RESPONSE TO COMMENTS
Draft Report dated December 11, 2004
Phase I Investigation - Soil Corrective Measures
Fire Training Area 04, Cannon Air Force Base, New Mexico

Comments received from Jane Davey, Project Manager, U.S. Army Corps of Engineers (USACE) on December 23, 2004.

REPORT
PHASE I INVESTIGATION
SOIL CORRECTIVE MEASURES
FIRE TRAINING AREA 04
CANNON AIR FORCE BASE, NEW MEXICO

Figure 3
Sample Locations With Results

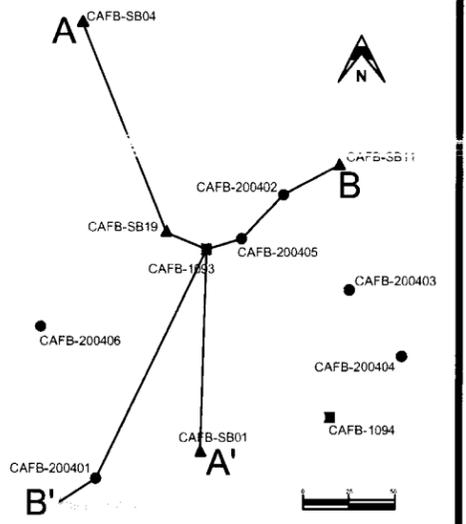
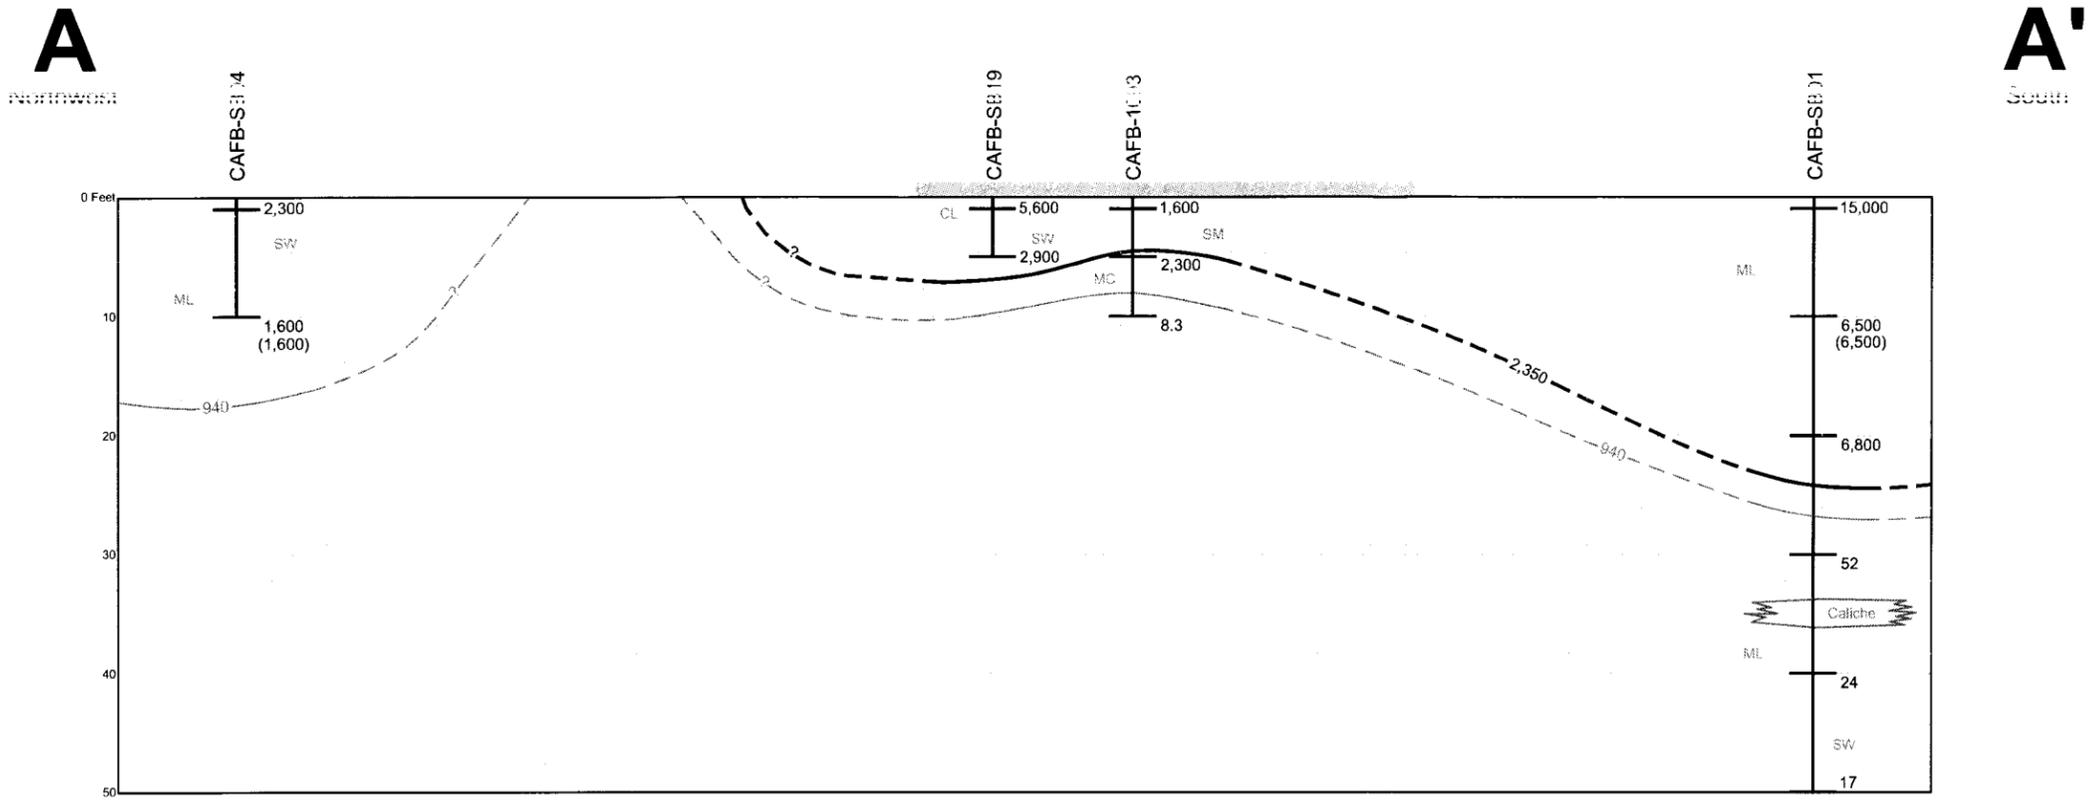
1. Figure3 – The field duplicate results for samples CAFB-SB04, CAFB-200405, and CAFB-SB01 need to be included on this figure.

5. Section 4.2: Just a note... We may want to revise the GIS coverage of the location of the former concrete pad. The locations of the soil borings were, for the most part, found from original markers still remaining in the field. If the relative location of the former concrete pad and the original soil borings is correct, the GIS coverage for the pad needs to be moved to the southwest as shown in Figure 3.

6. Section 5: Please verify where soil boring SB04 was located in the field. Was it located adjacent to the pipe structure still remaining on the site from previous operations? This area is definitely suspect. While staking sample locations stained and distressed vegetation was observed at this location and we were unsure whether SB04 was originally located here or elsewhere since a marker could not be found at the time for SB04.

Response: Addition made.

Response: After further discussion of this comment with Ms. Bieniulis, the location of the former concrete pad outline (on Figure 3) was moved to the southwest. This location on the drawing provides better agreement with how the boreholes were located in the field and with Ms. Bieniulis' knowledge of the site. Additionally, the revised Figure 3 pad location coincides with field observations of the depression that collected rain water at the time of the investigation. However, the revised location does not agree with survey coordinates that we were provided.

Response: We are confident of the location of SB04 as shown on Figure 3. The distressed vegetation area and stand pipe near this boring can be seen in Appendix F, Photo #573. Text for this photograph was revised to indicate the drilling location of SB04.
